UNITED STATES PATENT AND TRADEMARK OFFICE

APPLICATION NO.	FILING DATE	FIRST NAMED INVENTOR	ATTORNEY DOCKET NO.	CONFIRMATION NO.
10/636,120	08/07/2003	Gerardo Orozco-Abundis	200206588-1	1561

Office Action Summary

DETAILED ACTION

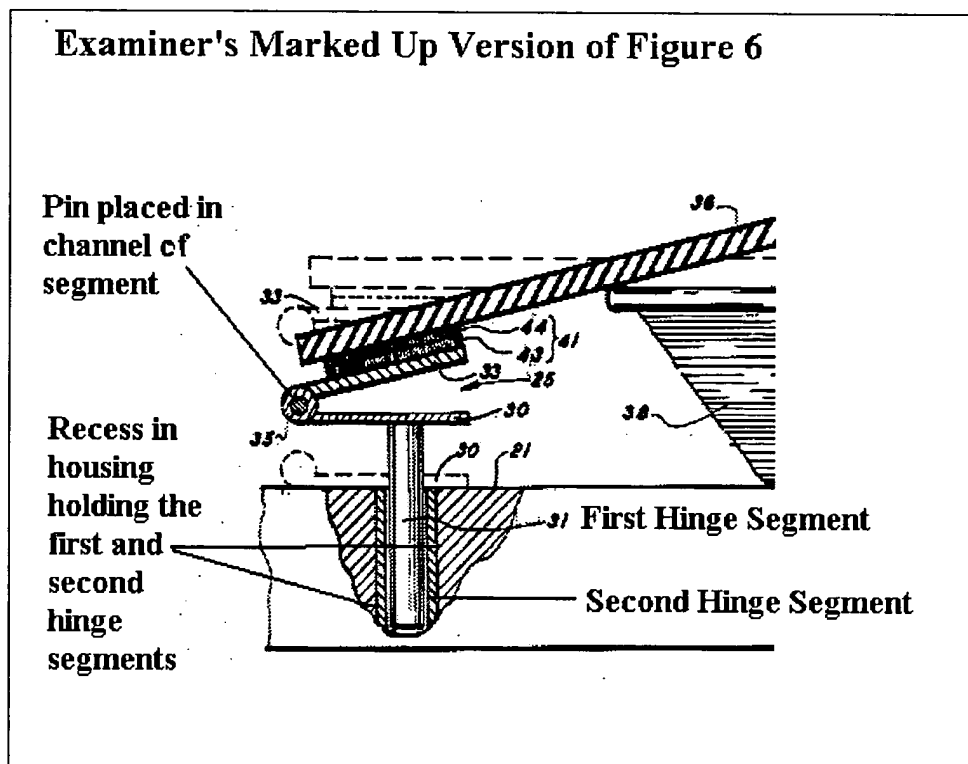
With respect to claim 3, Figure 6 shows at least one slot (recess) 32 in the housing 21, the at least one slot 32 operable to engage with at least a portion (First Hinge Segment) of said at least one telescopic hinge 35 to prevent inadvertent decoupling of said at least one telescopic hinge 35 from said housing 21. (See the Examiner's Marked-up Figure Below)

With respect to claim 4, Figure 6 of Wakeman illustrates the housing having at least one recess corresponding to the at least one telescopic hinge 35. (See Figure Below.)

With respect to claims 4 and 5, Figure 5 of Wakeman illustrates the housing having a plurality of recesses, with each telescopic hinge 35 being inserted into a corresponding recess 32 to couple said lid 36 with the housing 21. The recess is also illustrated in the Examiner's Marked-up version of Figure 6.

With respect to claims 6 and 8, the at least one telescopic hinge 35 of Lee et al., the Examiner's Marked-up version of Figure 6 shows a first and second hinge segments. Figure 6 shows at least one hinge segment disposed in the recess in the housing 21.

With respect to claim 7 and 9, as illustrated by the dotted lines in Figure 6, the first and second hinge segments are slidably engaged with each other.

With respect to claims 13 and 14, Figure 6 of Wakeman teaches the first segment comprising a ledge 30 near an end of the first segment, the ledge surrounding an opening (recess) at the end. See the Examiner's Marked-up copy of Figure 6.

With respect to claims 15 and 16, the top outer portion of the second hinge segment, as shown in Figure 6, constitutes a latching member because that top outer portion engages the ledge 30 (broken line illustration in Figure 6) to restrict motion. The top outer portion surrounds an end of the second segment.

With respect to claim 18, the Examiner's Marked-up version of Figure 6 shows a segment, generally shown at 33, comprising a channel operable to accept a pin to pivotally couple the lid to the hinge.
